# **SERVICE BULLETIN**

**December 5, 1986**

# 1987 XLH IGNITION MODULES AND LEFT MAIN BEARING END-PLAY

Figure 1. Ignition Module Identification

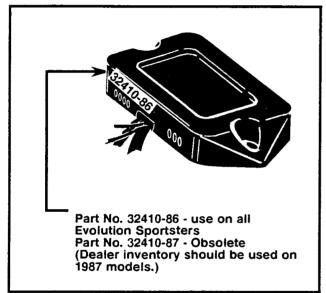
Testing at the factory has shown that the 1986 ignition module, Part No.32410-86, provides performance equal to that provided by the 1987 ignition module. See Figure 1. Beginning with crankcase number 1787 314 005 on 883cc models and 1887 311 005 on 1100cc models, ignition module, Part No. 32410-86 is being installed at the factory. Part No. 32410-87 has been obsoleted. Dealers can service all XLH Evolution models by stocking only one module.

See Figure 1. The Part No. is stamped on the module as shown. Orders for the 32410-87 module will be filled with the 32410-86 module. Any 32410-87 modules in stock at your dealership should be used on 1987 models. PART NO. 32410-86 MODULES MAY BE USED ON ALL EVOLUTION XLH MODELS (1986 and 1987, 883cc and 1100cc).

Figure 2. Checking Flywheel End-Play

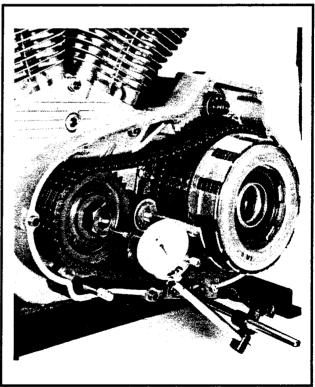
When performing an entire engine overhaul, it is important that the left main bearing end-play be within the newly recommended 0.001 to 0.005 in. specification to prevent bearing damage.

Individual shims are now available for XLH sprocket shaft bearings. Flywheel end-play can now be adjusted by selecting the required bearing shim. The end-play specification previously was 0.001-0.007 in. The endplay Service Wear Limit remains at 0.007 in.

1. See Figure 2. Secure a dial indicator to crankcase with indicator stem against sprocket shaft nut.

2. Rotate flywheels and at the same time, push and pull on the sprocket shaft. Read shaft travel on dial indicator. Shaft end-play should not exceed 0.007

in. If end-play exceeds maximum, sprocket shaft bearings should be inspected.
